Proposal for amendments to UN Regulation No. 46 (Devices for indirect vision)

I. Proposal

**Figure 1
Example for the measurement by maximum variation"**

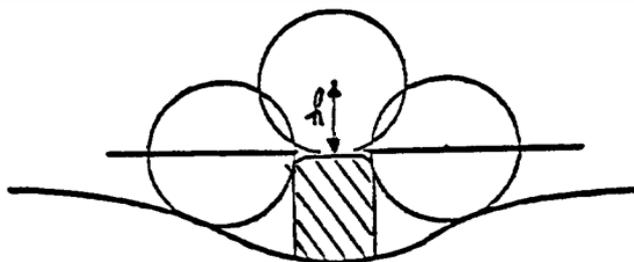
"6.2.2.1.2.2. **If the dimension of the projection of a component which is mounted on a surface other than convex cannot be determined by simple measurement, it shall be determined by the maximum variation of the distance of the centre of a 100 mm diameter sphere from the nominal line of the panel when the sphere is moved over and is in constant contact with that component. Figure 1 shows an example of the use of this procedure.**
